SUBMITTAL OF HANFORD FACILITY RESOURCE CONSERVATION AND RECOVERY ACT (RCRA) PERMIT MODIFICATION NOTIFICATION FORM 24590-LAW-PCN-ENV-11-002, REPLACE PIPING AND INSTRUMENTATION DIAGRAMS (P&ID) DRAWINGS FOR LOW-ACTIVITY WASTE (LAW) PRIMARY OFFGAS PROCESS SYSTEM (LOP) IN APPENDIX 9.2 OF THE DANGEROUS WASTE PERMIT (DWP)

Hanford Facility RCRA Permit Modification Notification
Form 24590-LAW-PCN-ENV-11-002

The purpose of this Class 1 prime modification is to update the P&ID drawings for the LAW LOP System in Appendix 9.2 of the DWP.

| DWG NO | TITLE |
|---------------------------|--|
| 24590-LAW-M6-LOP-00004001 | PRIM OFFGAS PROC SYS MELTER 1 LOP-FCLR-00002 |

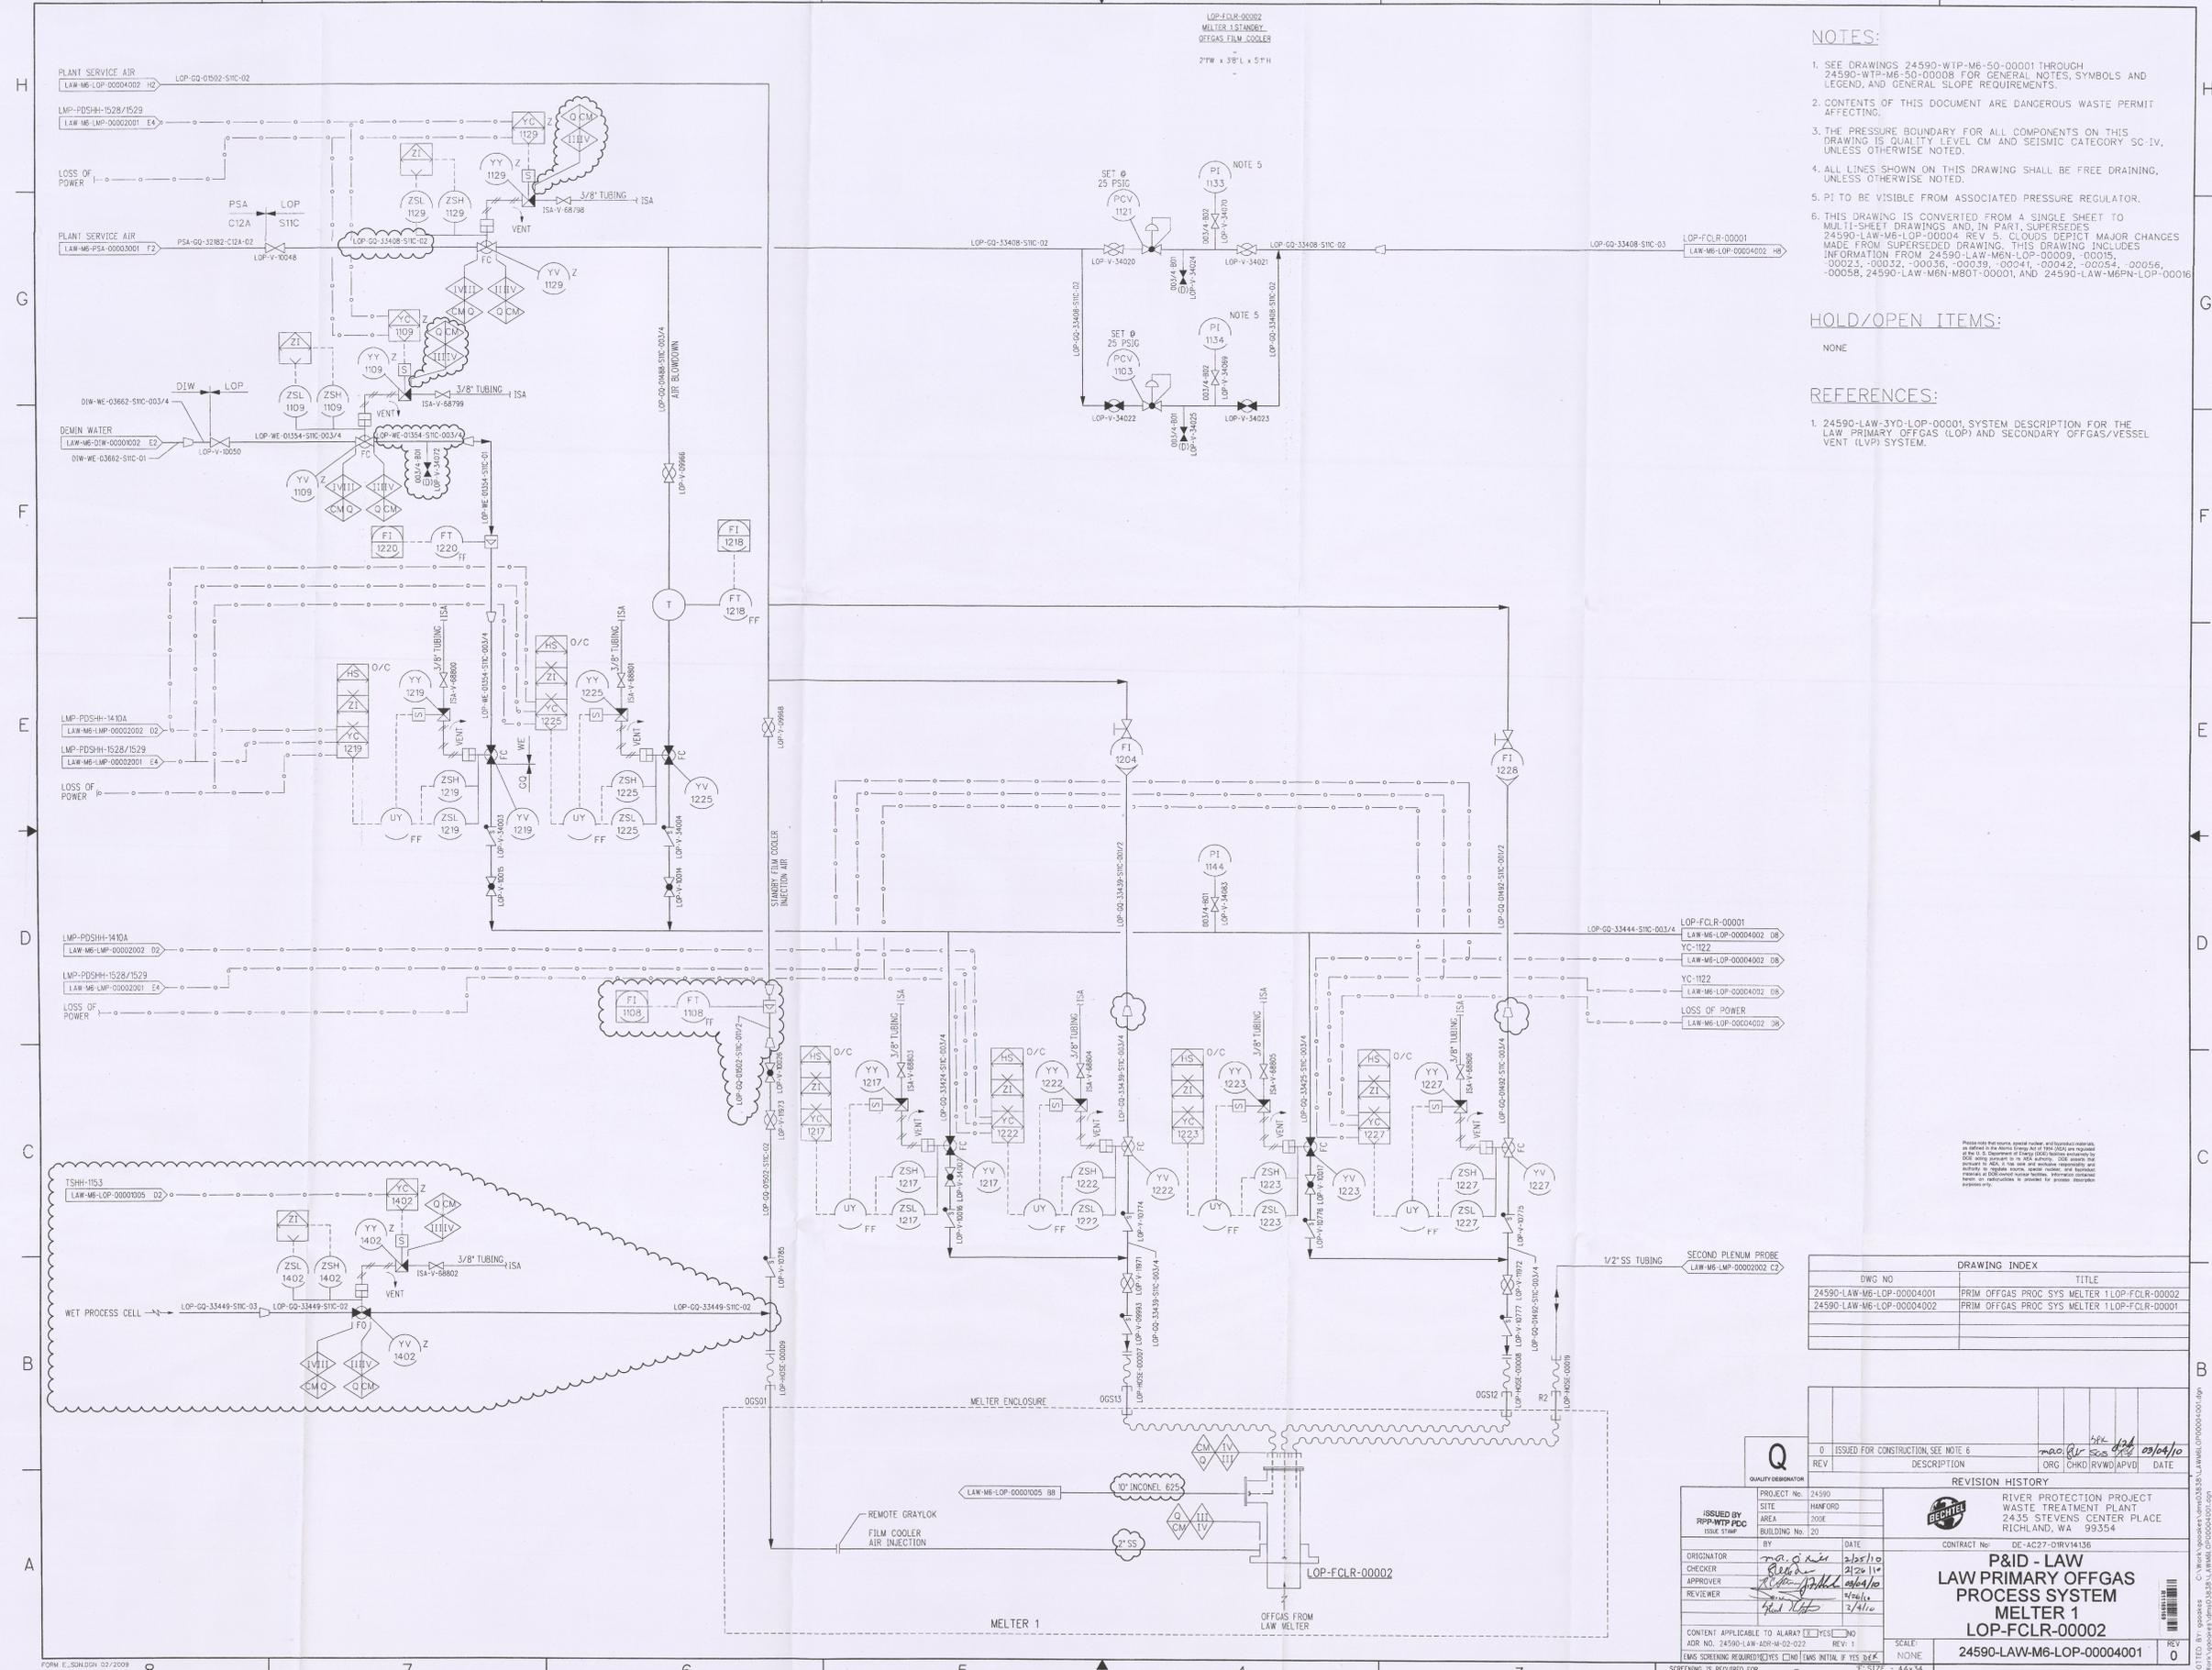
- Converted from single sheet to multi-sheet format with each sheet documenting one of the following LOP equipment items:
 - LOP-FCLR-00002
 - LOP-FCLR-00001
- Deleted HEPA filters

P&ID - LAW LAW PRIMARY OFFGAS PROCESS SYSTEM MELTER 2 LOP-FCLR-00004

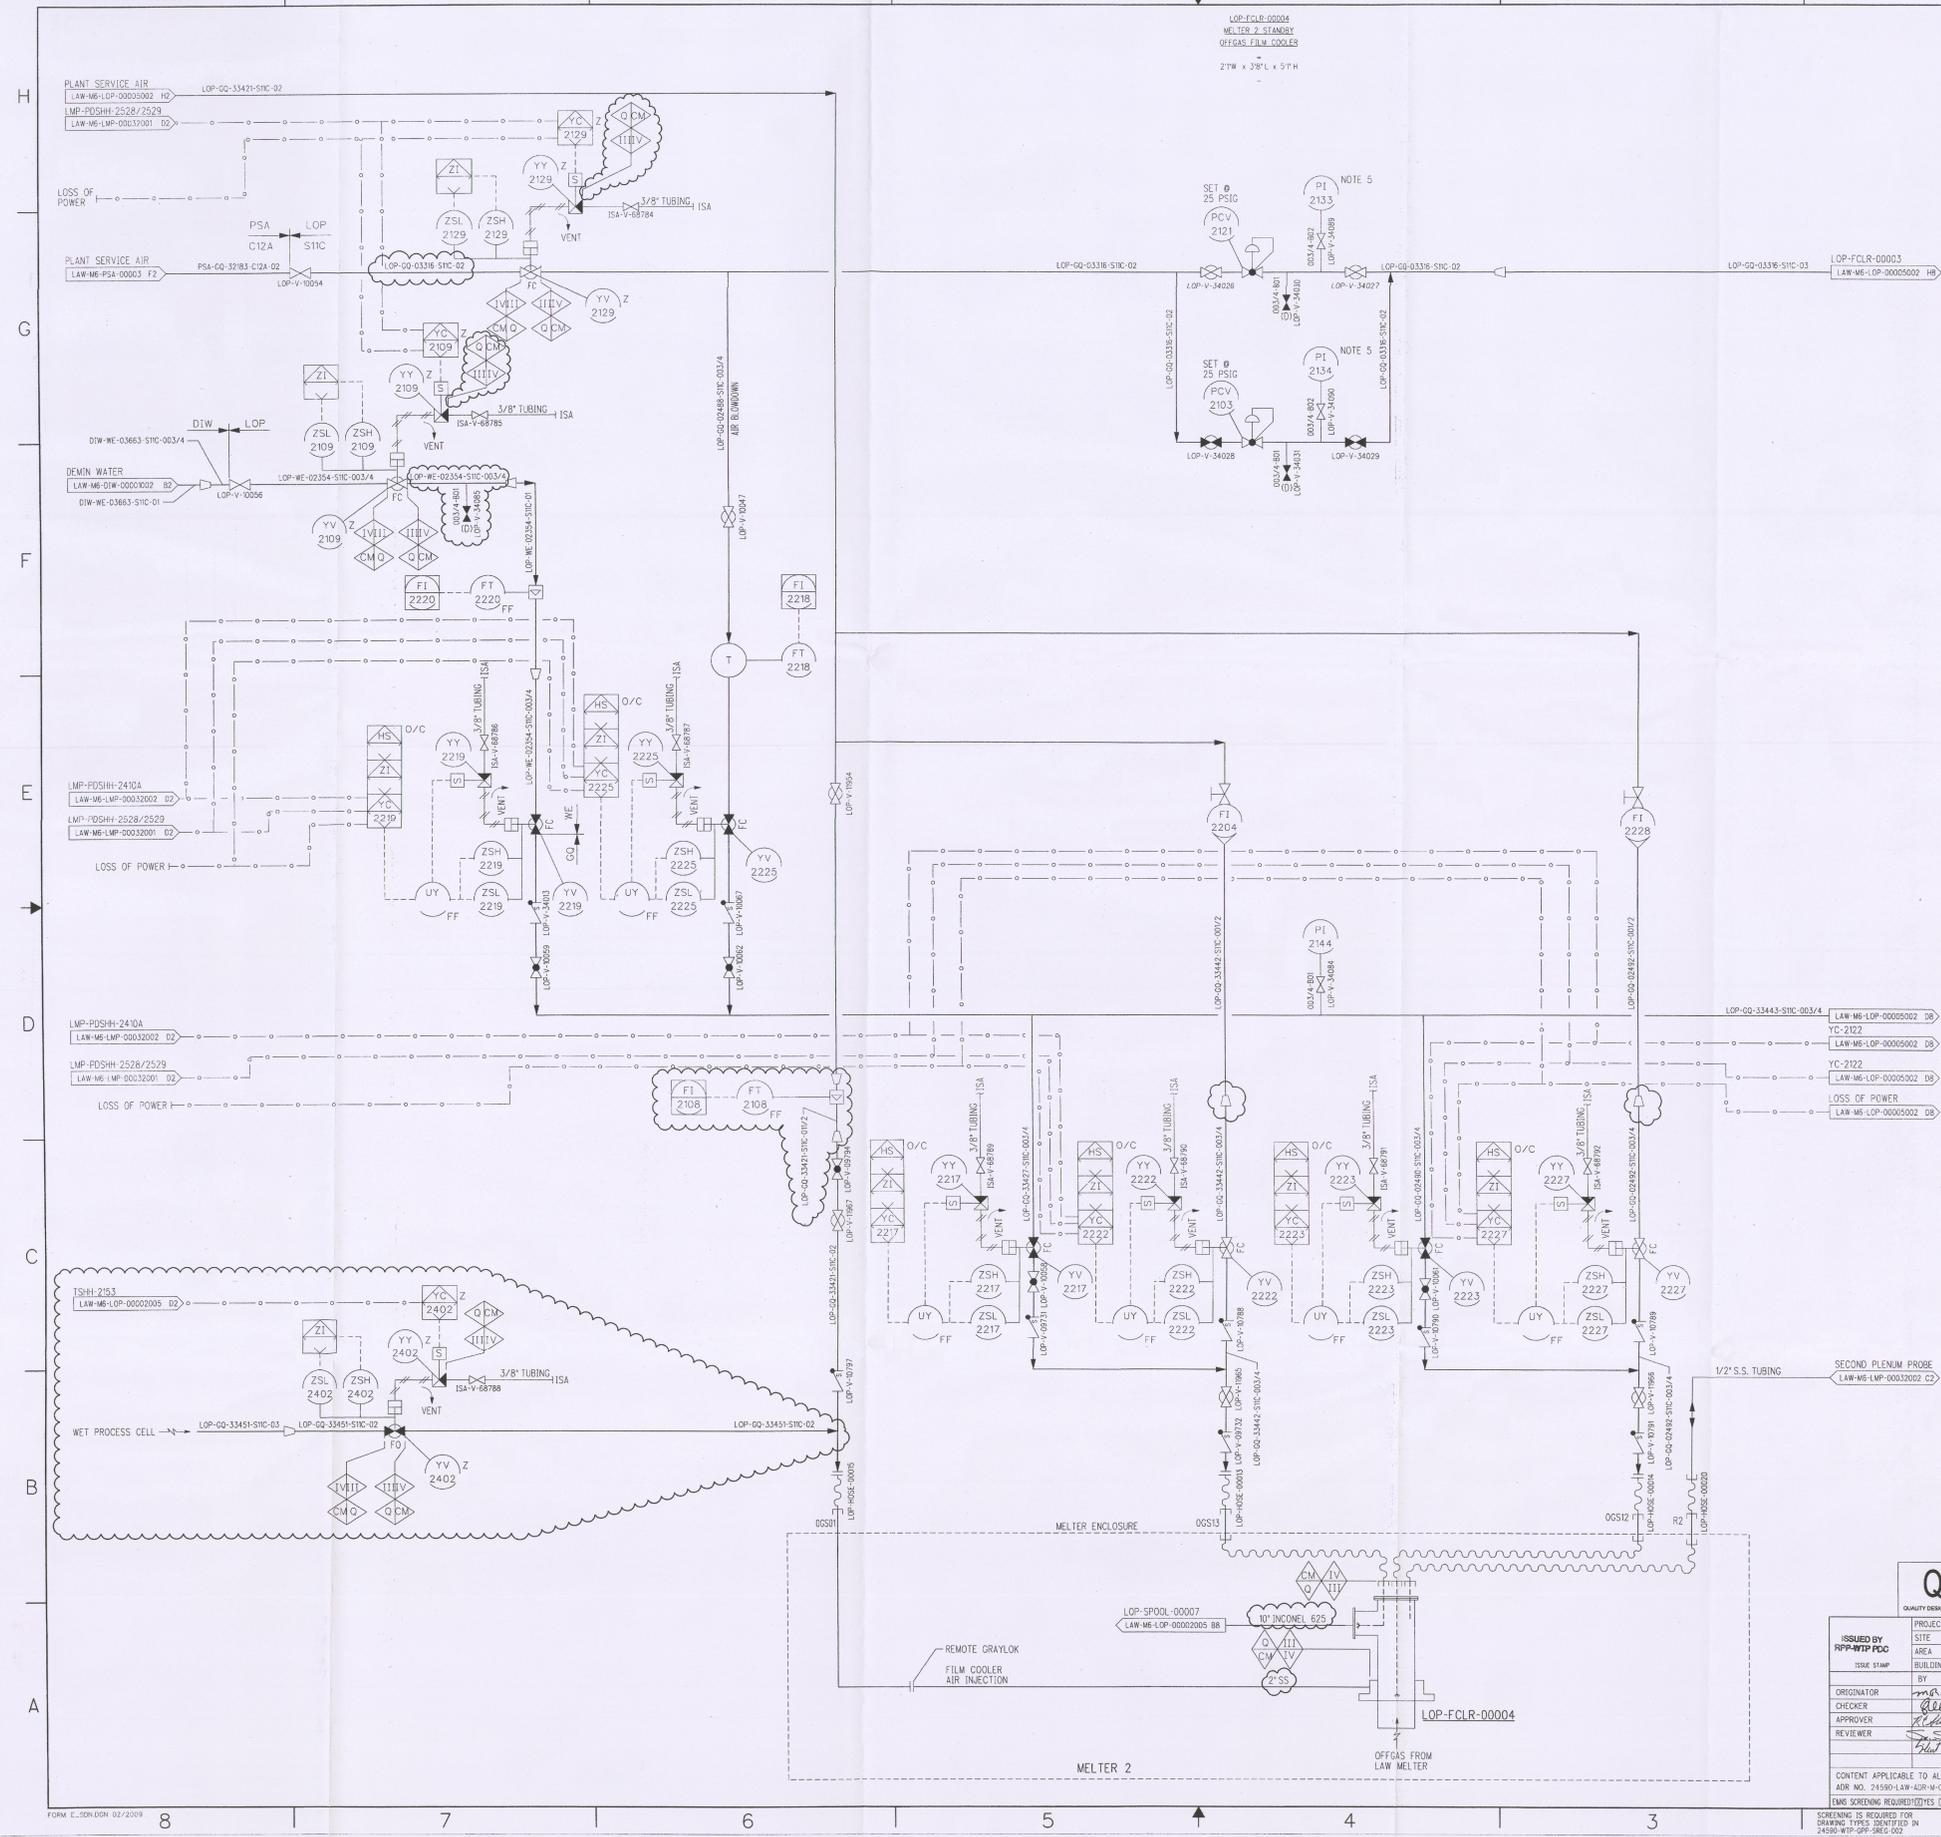
- Converted from single sheet to multi-sheet format with each sheet documenting one of the following LOP equipment items:
 - LOP-FCLR-00004
 - LOP-FCLR-00003
- Deleted HEPA filters

| P&ID - LAW LAW PRIMARY OFFGAS PROCESS SYSTEM MELTER 1 LOP-WESP-00001 | | | |

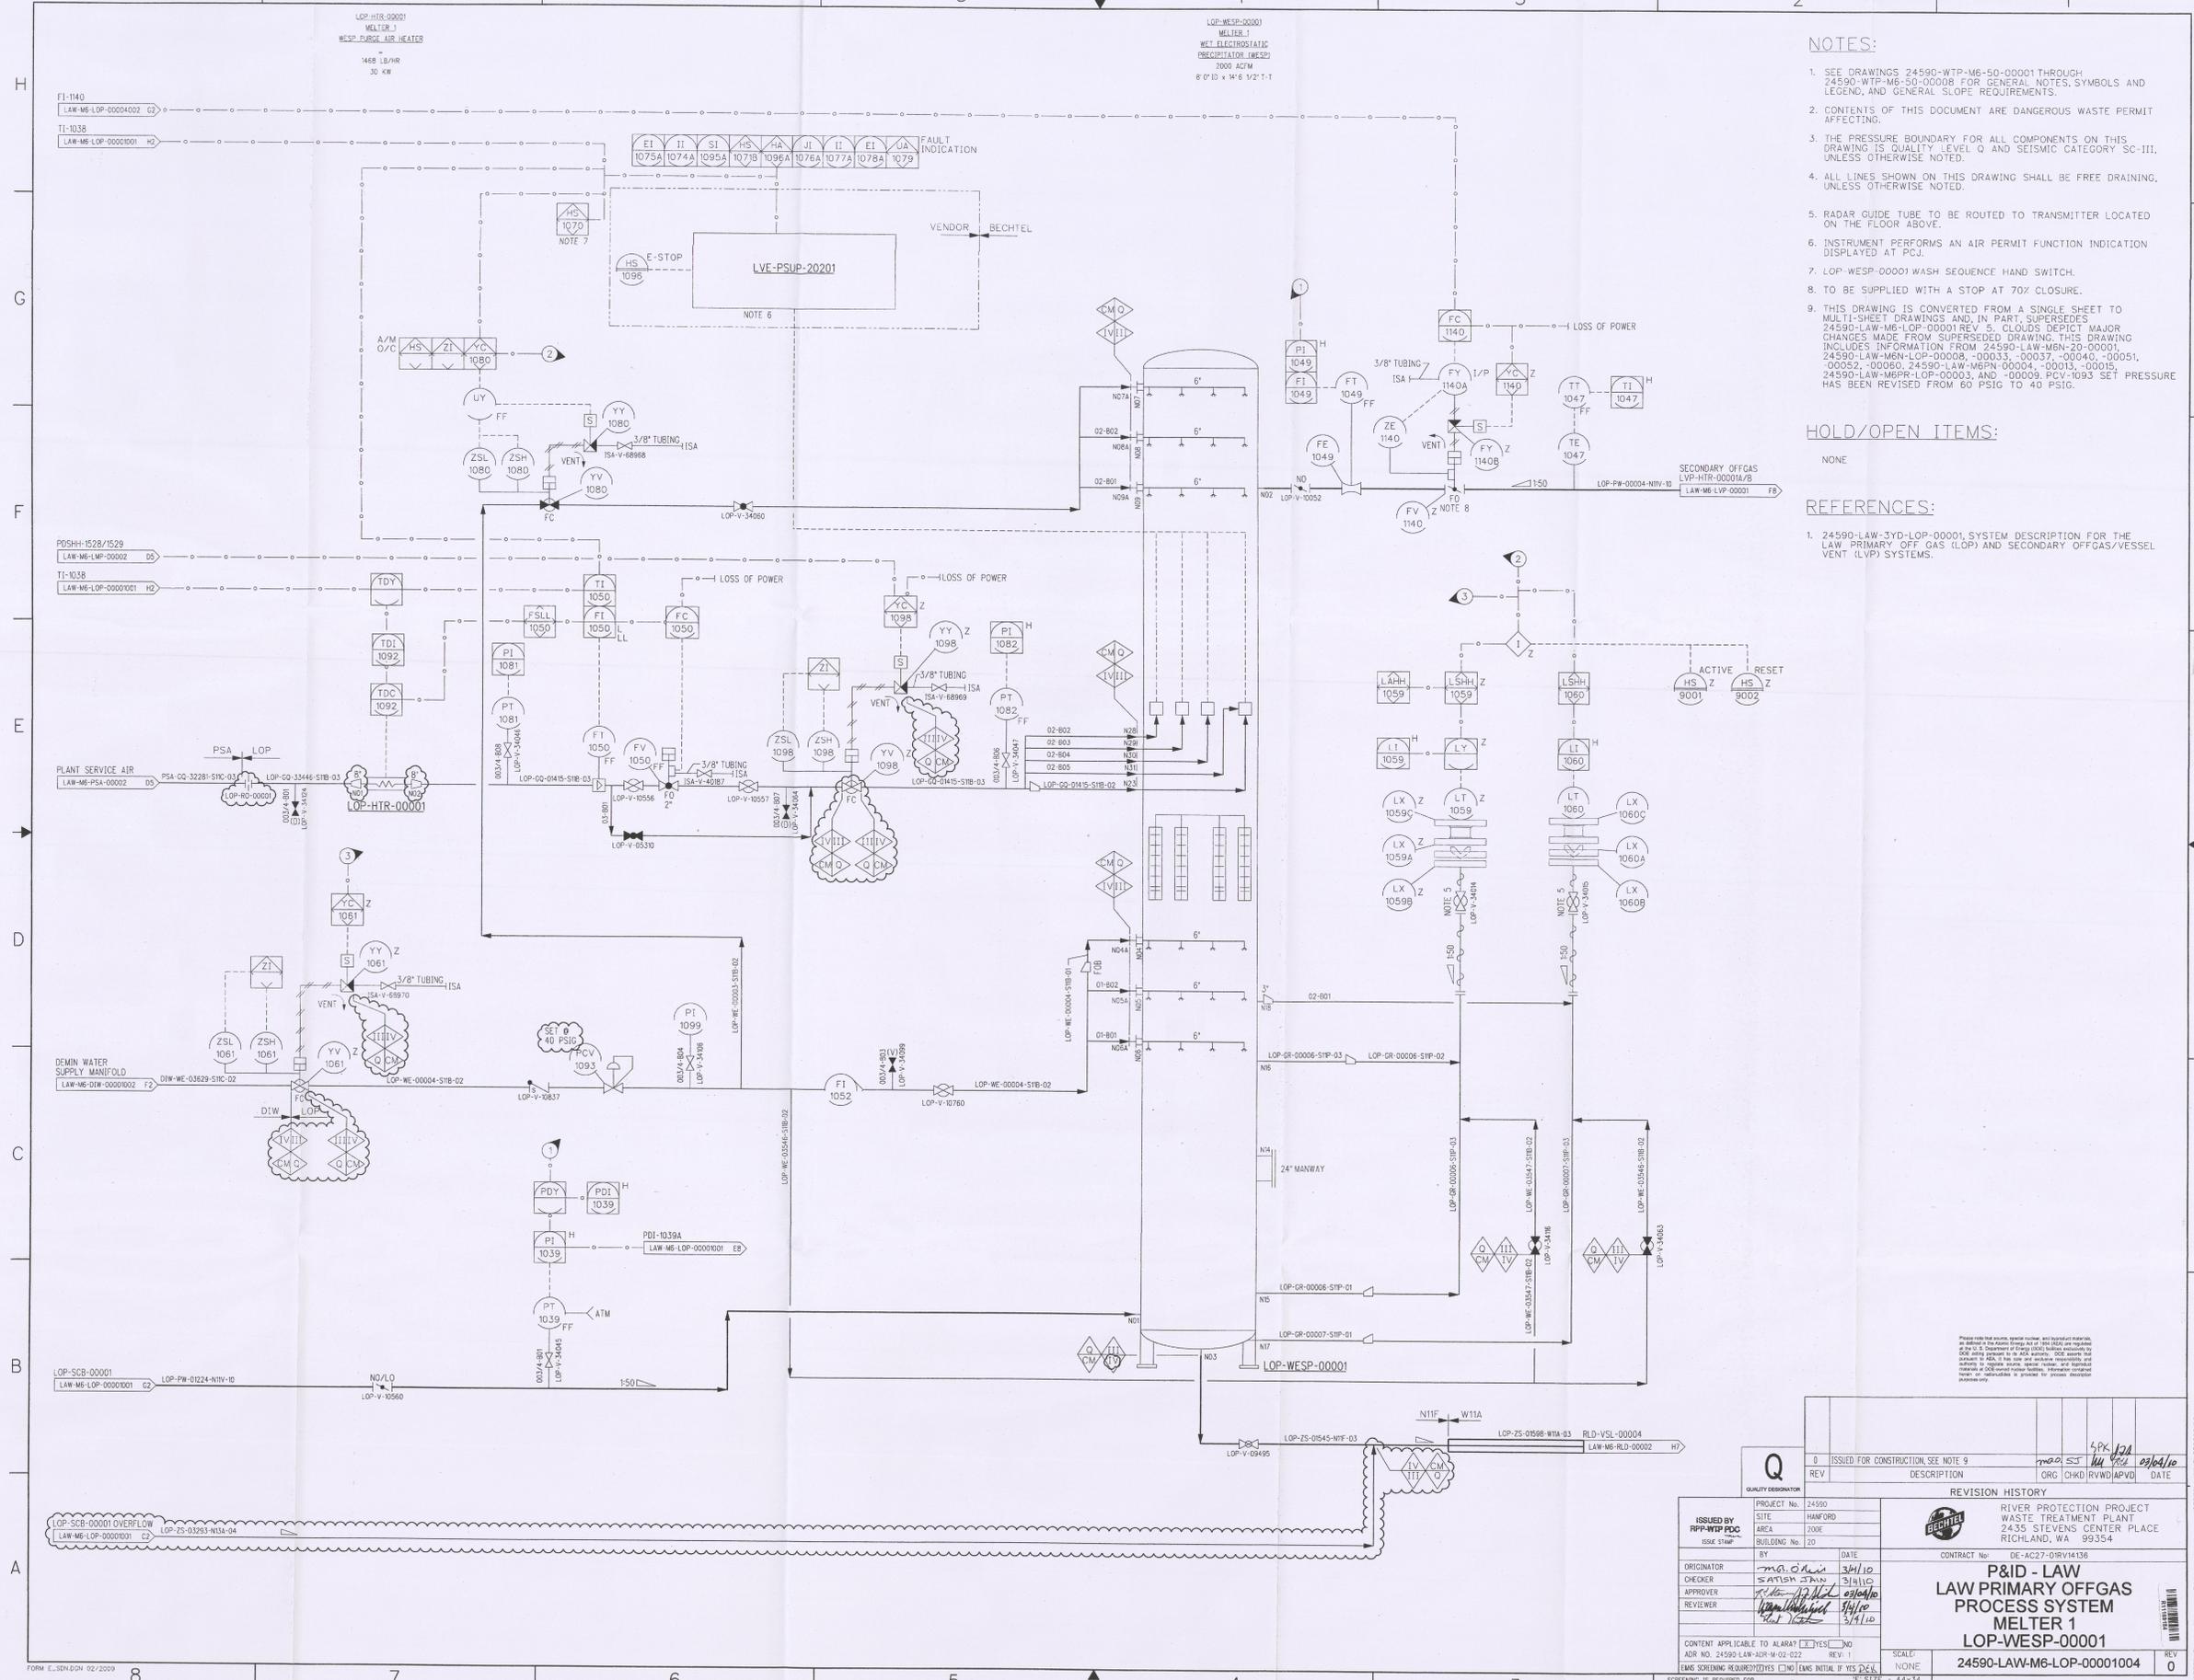
- TO BE SUPPLIED WITH A STOP AT 70% CLOSURE.
 - THIS DRAWING IS CONVERTED FROM A SINGLE SHEET TO MULTI-SHEET DRAWINGS AND, IN PART, SUPERSEDES 24590-LAW-M6-LOP-00001 REV 5. CLOUDS DEPICT MAJOR CHANGES MADE FROM SUPERSEDED DRAWING. THIS DRAWING INCLUDES INFORMATION FROM 24590-LAW-M6N-20-0001, 24590-LAW-M6N-LOP-00002, -00003, -00037, -00040, -00051, -00052, -00060, 24590-LAW-M6PN-00004, -00013, -00015, 24590-LAW-M6PR-LOP-00003, AND -00009. PCV-1093 SET PRESSURE HAS BEEN REVISED FROM 60 PSIG TO 40 PSIG.
